Nuttall Consulting

Report – Principle Technical Advisor Aurora Electricity Distribution Revenue Review

A report to the AER

11 November 2011

Figure 6 - Capex per customer

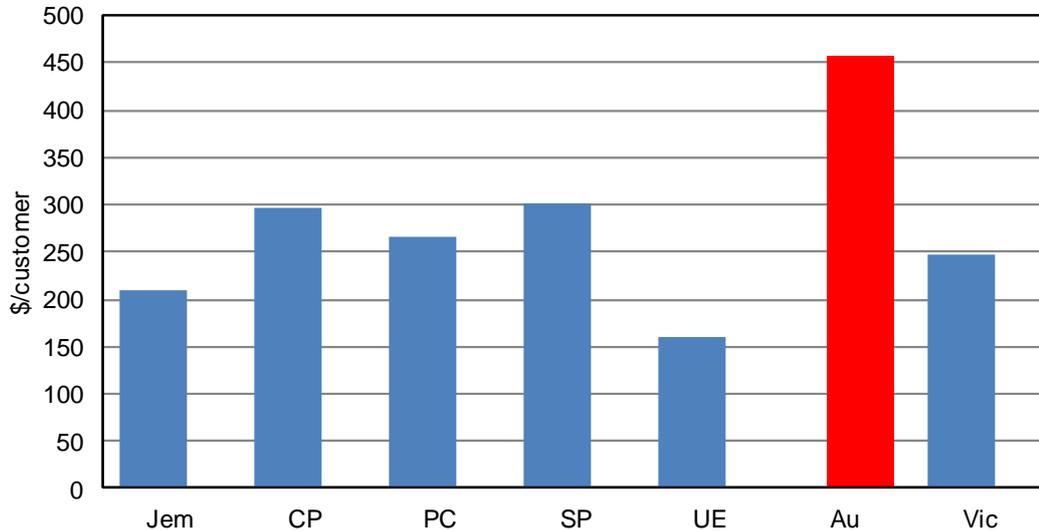
The following chart (Figure 6) provides a comparison of the capex/customer ratio for Aurora and each of the Victorian DNSPs. The average Aurora capex per customer for the

last 5 years is higher than the Victorian (5 DNSP) average and higher than each of the individual Victorian DNSP 5-year averages.

Figure 8 - capex per customer¹⁷

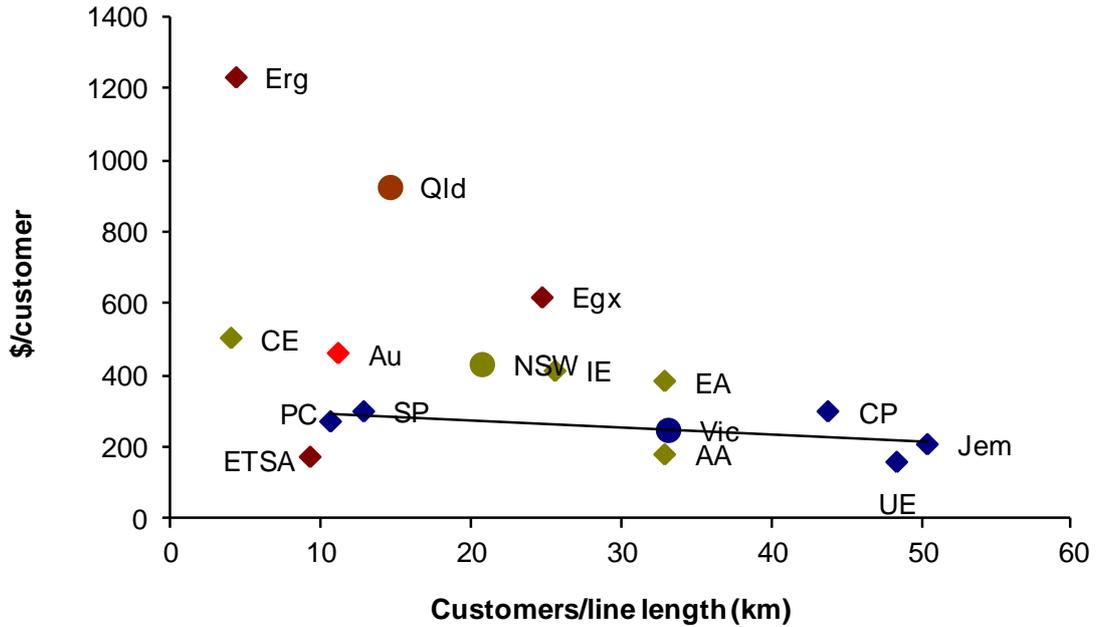
Figure 8 shows the capex spent¹⁶ per customer for each of the NEM DNSPs.

Figure 9 – Aurora capex

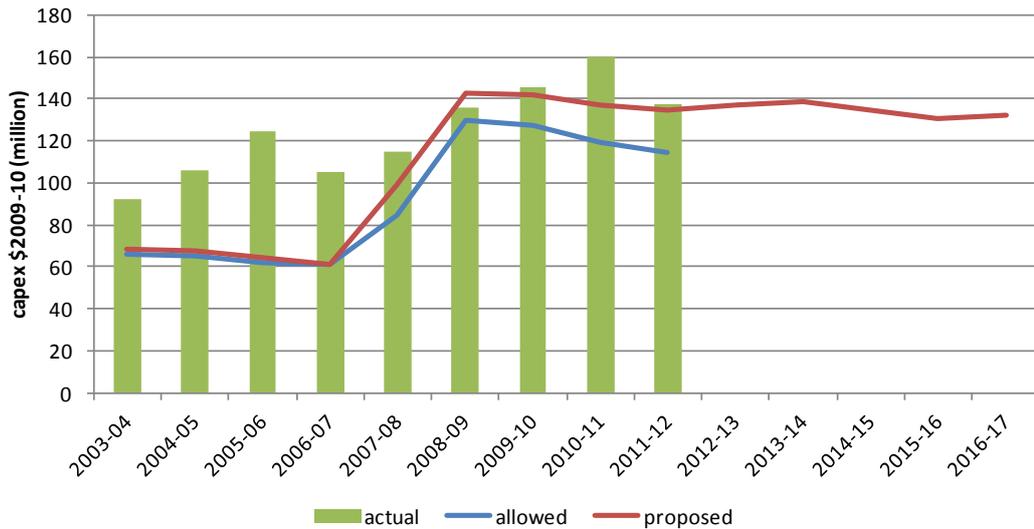
Figure 9 provides the actual, forecast and allowed capex for Aurora since 2003/04.¹⁸

The reasons for the general level of overspend are not clearly evaluated in the Aurora submission. There are a number of items identified at the sub-category capex level that are stated to have contributed to variations from expected expenditure, but these are not discussed in detail or quantified.

Observation: Aurora has consistently forecast lower levels of expenditure than have actually been incurred, although there is a significant level of variability in the level of forecast inaccuracy. Aurora has significantly revised the processes for developing regulatory forecasts.

Figure 14 Reinforcement – HV feeder and zone substation capex trends

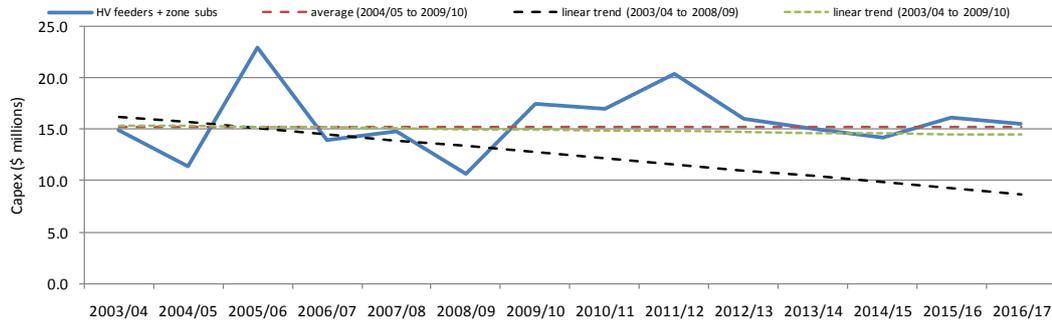
Figure 14 below shows the profile of capex allocated to HV feeders and zone substations (the solid blue line). This includes the actual capex prior to 2010/11, and the estimate and forecast from 2010/11. The chart also includes an indication of average and linear trends of actual capex (the dashed lines) for comparative purposes.

As noted above, we have reviewed a significant number of projects and programs to assess the reasonableness of Aurora’s forecast. A broad finding of our review of these projects and programs is that the methodology applied by Aurora to produce the forecast is appropriate to identify possible needs and strategic solutions. To a reasonable degree, this process aligns with the actual planning processes Aurora applies in its normal planning activities.

Figure 16 Reinforcement – LV network capex trends

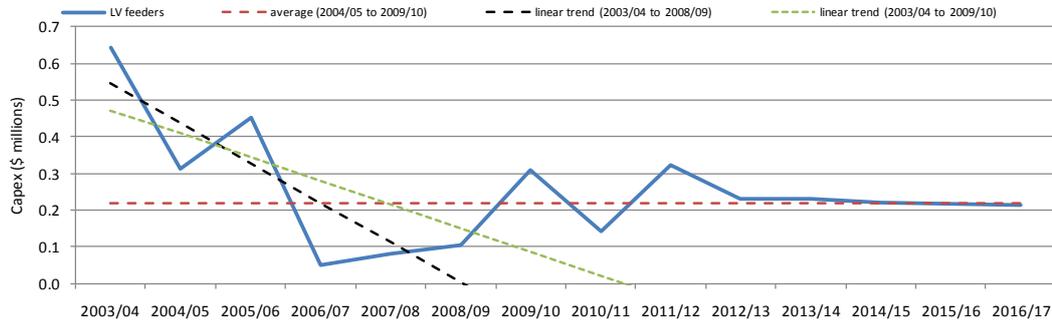
Figure 16 below shows the profile of capex allocated to LV networks (the solid blue line). This includes the actual capex prior to 2010/11, and the estimate and forecast from 2010/11. The chart also includes an indication of average and linear trends of actual capex (the dashed lines) for comparative purposes.

Given the low level of capex in this category and the fact that it is broadly on trend with recent levels, we have not reviewed this category in any detail and consider the forecast to be reasonable in the circumstances.

Figure 21 Non demand high level comparative analysis results - focus

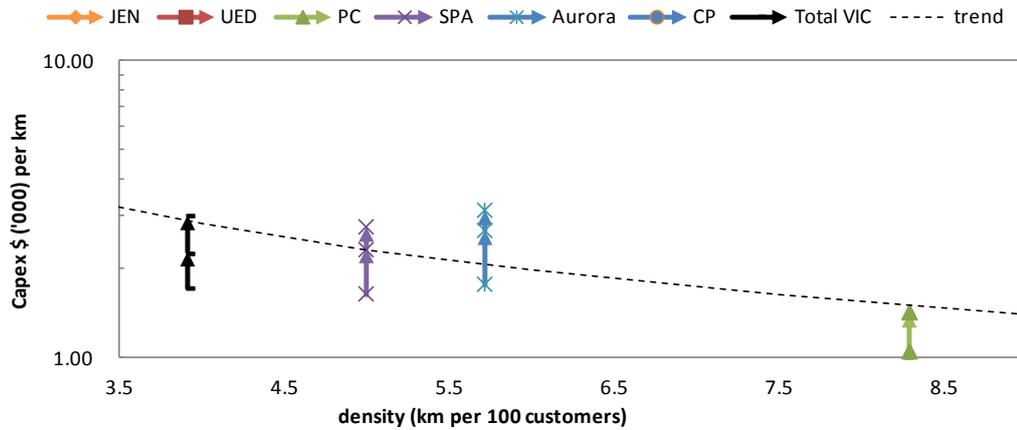
This analysis suggests that Aurora’s non-demand capex is above the level required by the Victorian DNSPs for a similar scale and density. To illustrate the relative scale of this difference, Figure 22 below shows the percentage difference from the trend line for each DNSP and their non-demand capex in the previous, current and next regulatory periods.

Figure 44 - Historical IT and Communications capex (average per annum)

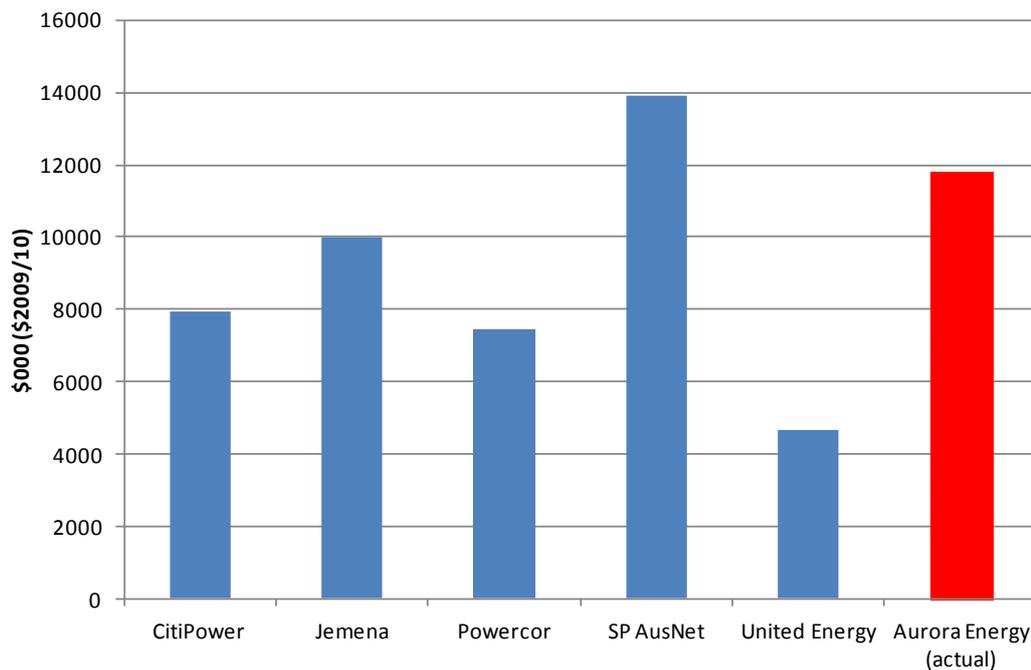
Figure 44 shows that the historical IT capex for Aurora is higher than that of the Victorian DNSPs with the exception of SP AusNet. The Victorian DNSPs are on average larger in network scale and customer numbers than Aurora. It is not immediately obvious why the IT expenditures incurred by Aurora would be greater than the average Victorian level of expenditure.

Figure 45 - IT and Communications capex (average per annum per customer)

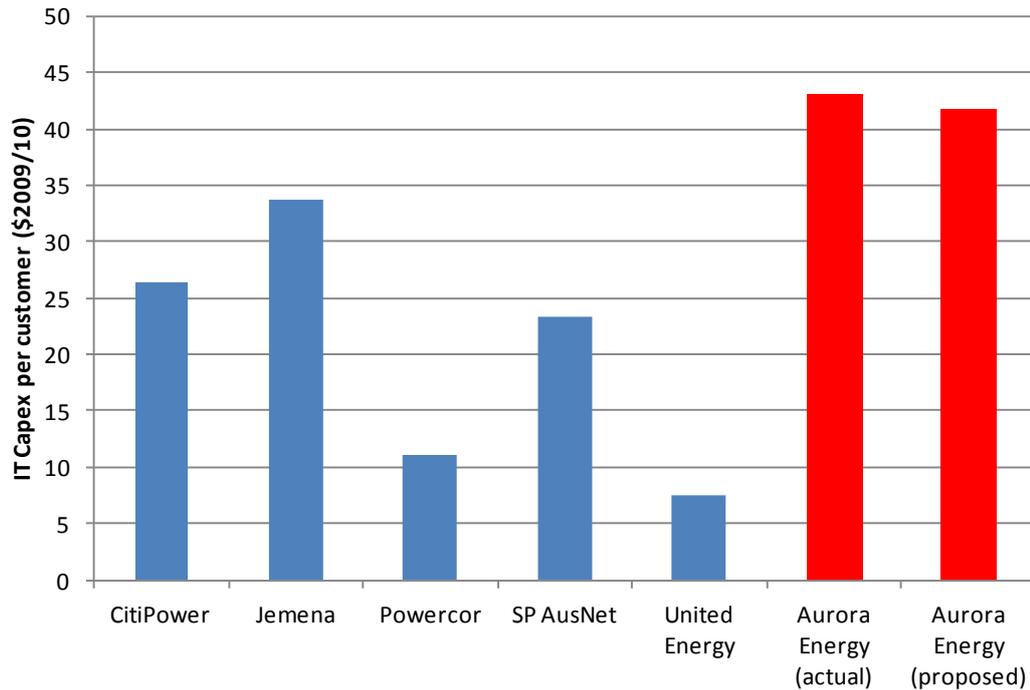
If we consider the IT expenditure on a per customer basis (Figure 45), we see that Aurora’s historical and proposed IT expenditure is greater than all of the Victorian DNSPs.
